SERVICE BULLETIN

NACELLE - POWER PLANT - FAN COWL DOORS, IDENTIFICATION PLATE - INSTALLATION OF:
REIDENTIFICATION OF - CATEGORY CODE 5 - MOD.NAC-71-0027

V2500-NAC-71-0027

Installation of the Identification Plate on the Left Fan Cowl Door
Fig.1

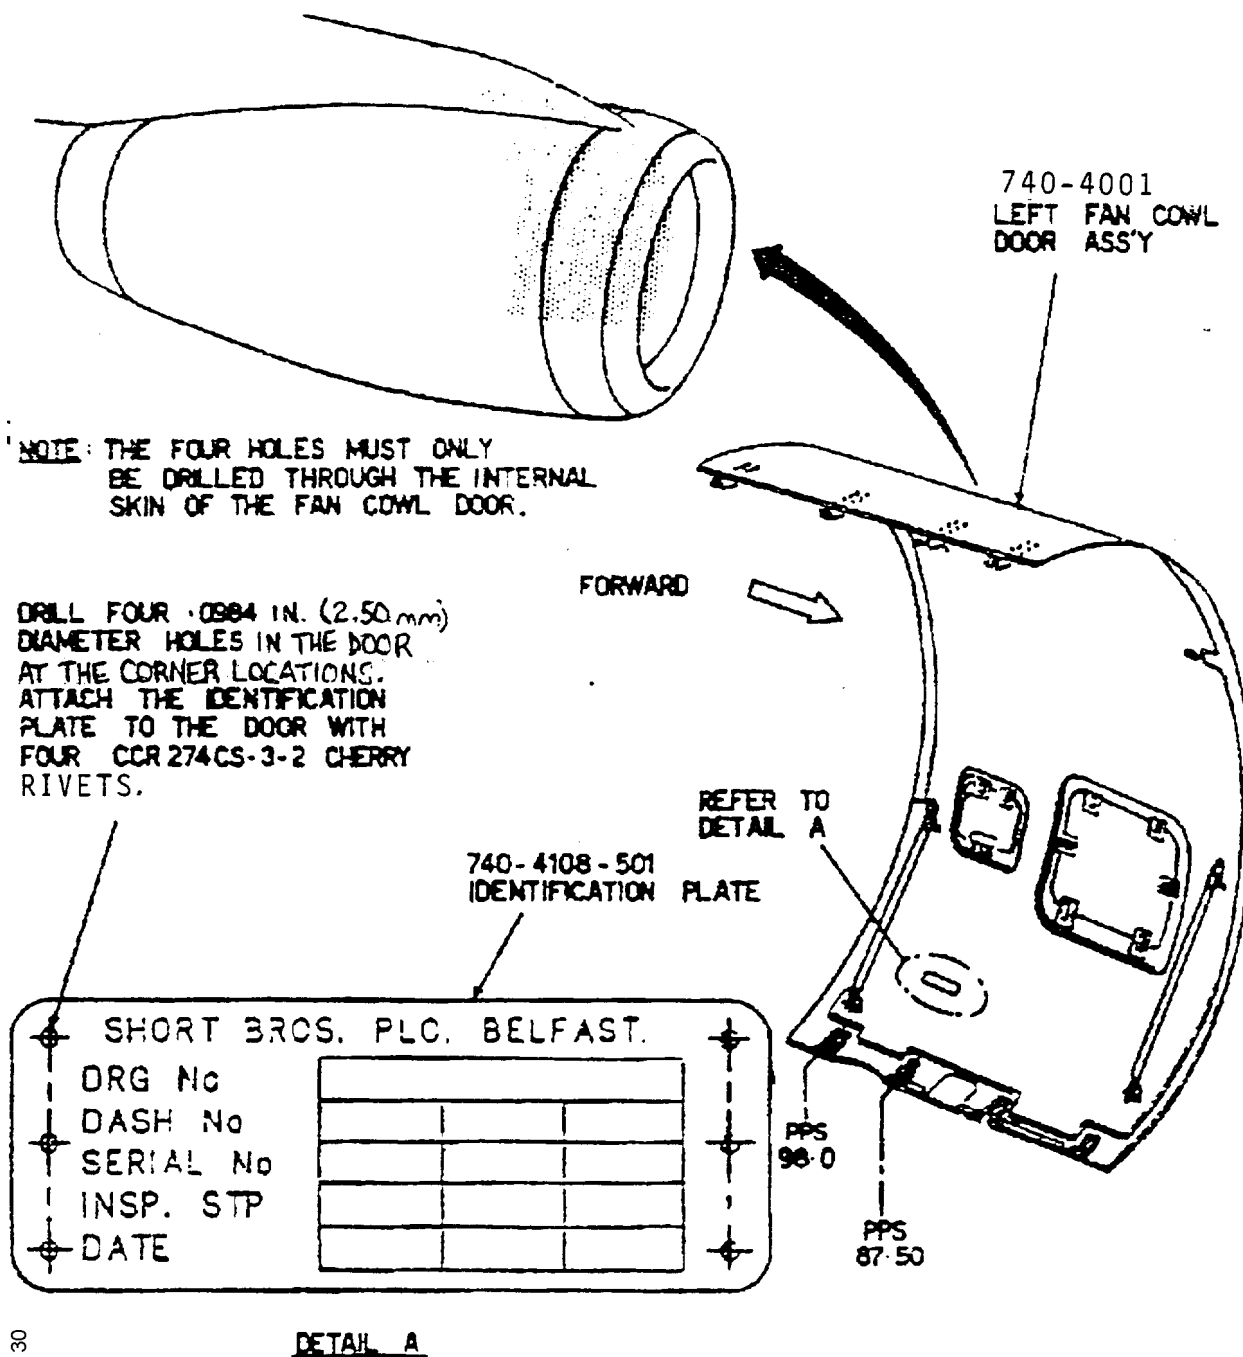
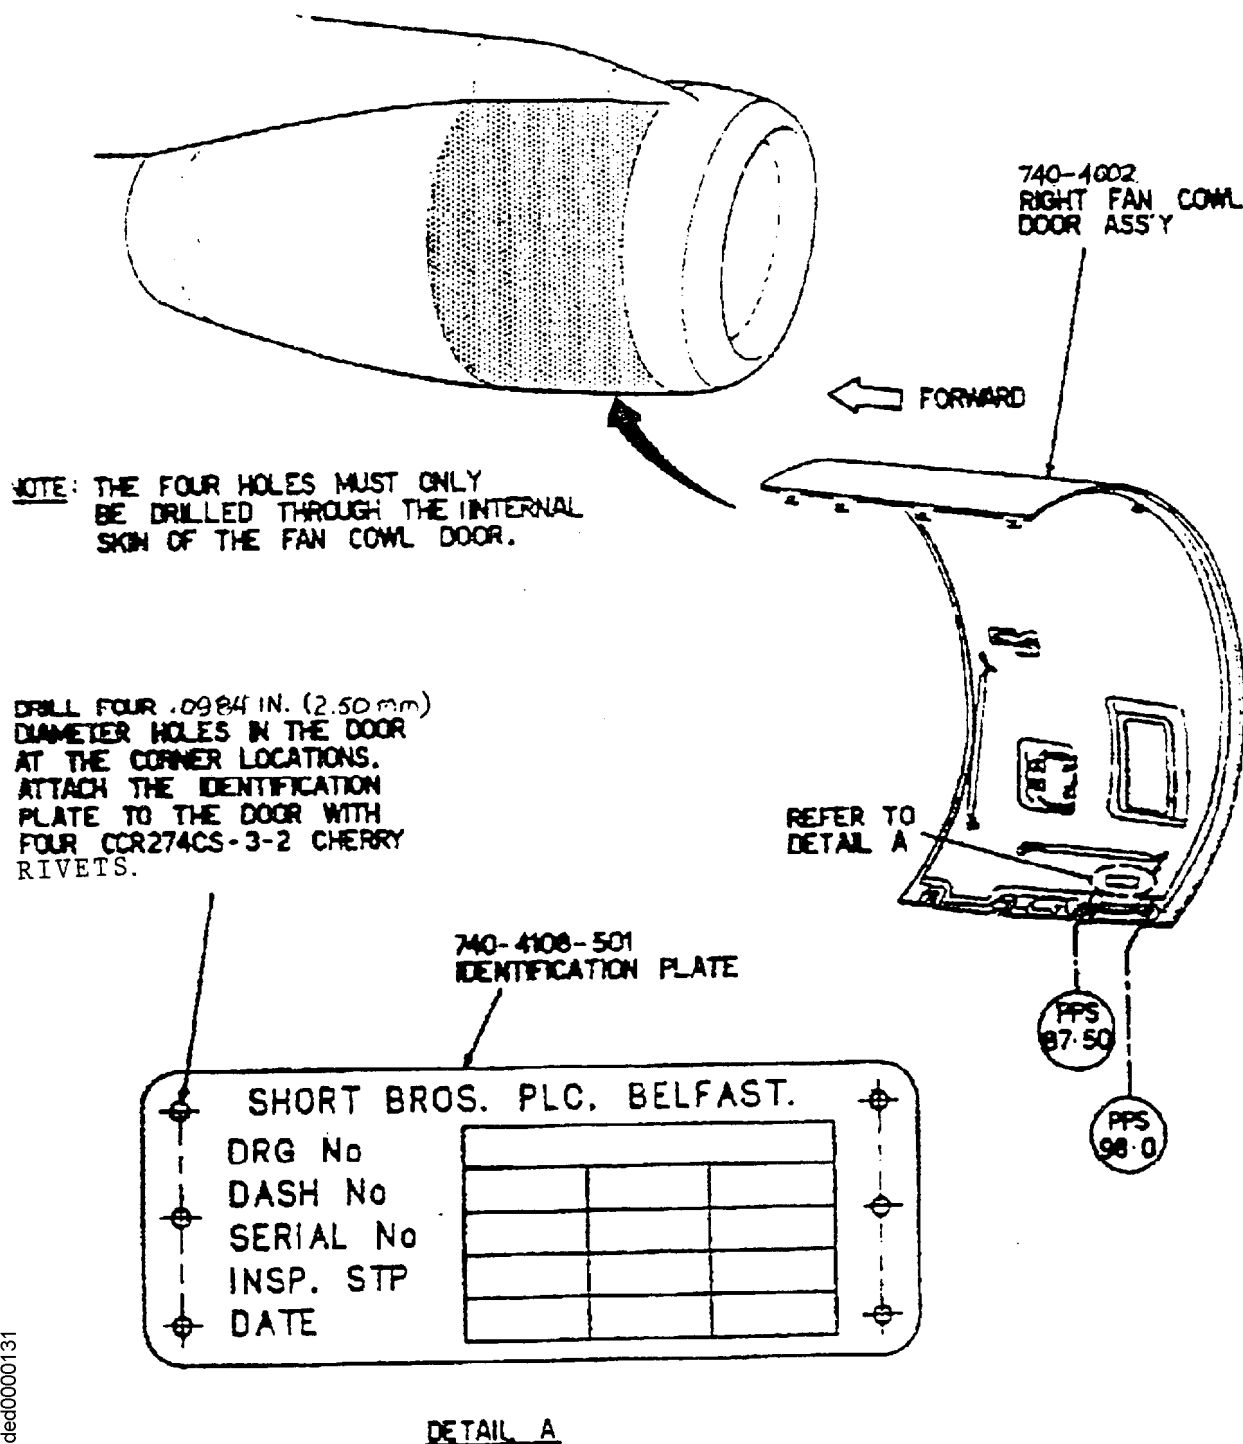
A 740-4108-501 identification plate is installed on the left fan cowl door at the location shown in Figure 1. The identification plate is attached to the fan cowl door with four CCR274CS-3-2 cherry rivets.

- (a) Hold the 740-4108-501 identification plate to the fan cowl door at the approximate location given in Figure 1. Make a mark around the contour of the identification plate.

- (b) Put the identification plate on the fan cowl door at the position marked in paragraph 2.B (1) (a). Hold the 740-4108-501 identification plate in position. Drill four 0.0984 inch (2.50 mm) diameter holes through the internal skin only of the fan cowl door at the corner locations. Use the 740-4108-501 identification plate as a template to do this task. (Refer to Figure 1.)

- (e) Apply a layer of PL32 Hylomar to the rear of the 740-4108-501 identification plate. Attach the identification plate to the door with four CCR274CS-3-2 cherry rivets. Remove any excess Hylomar with a clean cloth.
- (f) Reidentify the 740-4001-507, -55, -517, or -519 left fan cowl door as 740-4001-551.
- (2) If left fan cowl door is identified as 740-4001-551, -555, or -563, reidentify as 740-4001-571.
- (3) Rework the 740-4002-519, -521, or -523 right fan cowl door as specified in paragraphs 2.B.(1)(a) through 2.B.(1)(e). (Refer to Figure 2.) Reidentify 740-4002-519, -521, or -523 as 740-4002-563.
- (4) If right fan cowl door is identified as 740-4002-535, -543, Or -551, reidentify as 740-4003-563.
